SIL 08-EP-21
August 24, 2021
Page 1 of 2

SUBJECT: H 40/50 EP™ Input Damper and Damper Hub Part Changes

MODELS AFFECTED: H 40/50 EP™ Drive Unit

Figure 1. Input Damper (Former and Current)

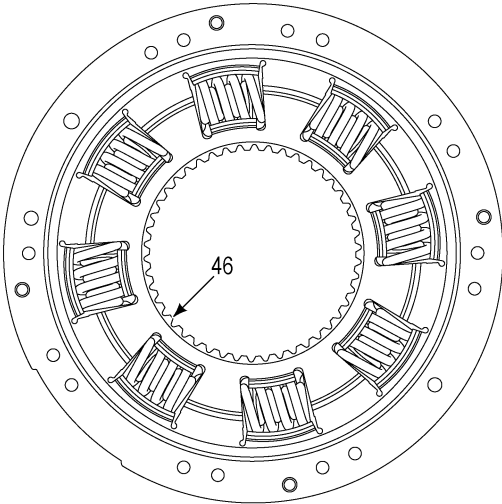
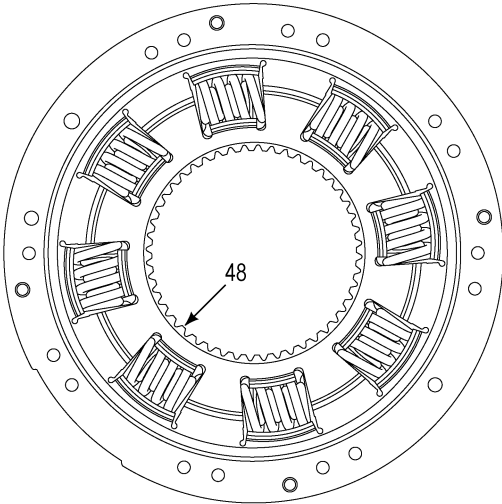
Beginning with S/N 7110010119 built on June 30, 2021, Allison Transmission, Inc. has changed the design of the input damper and damper hub for the H 40/50 EP™ Drive Unit. Both the input damper and damper hub have changed from 46 to 48 splines (refer to [Figure 1](#) and [Figure 2](#)).

Given the spline count change on both parts, the former and current parts are not compatible. The former 46-spline input damper has been canceled and will be serviced by the current 48-spline input damper after remaining 46-spline input damper stock is used. The current 48-spline input damper is now available for service.

Figure 2. Damper Hub (Former and Current)

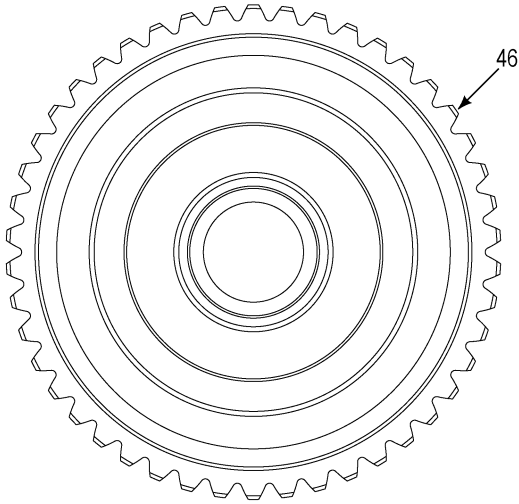
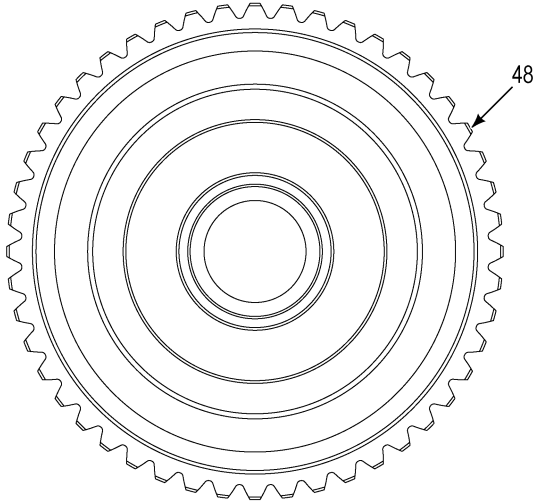
The former 46-spline damper hub has been canceled and will be serviced by the current 48-spline damper hub after remaining 46-spline damper hub stock is used. The current 48-spline damper hub is now available for service.
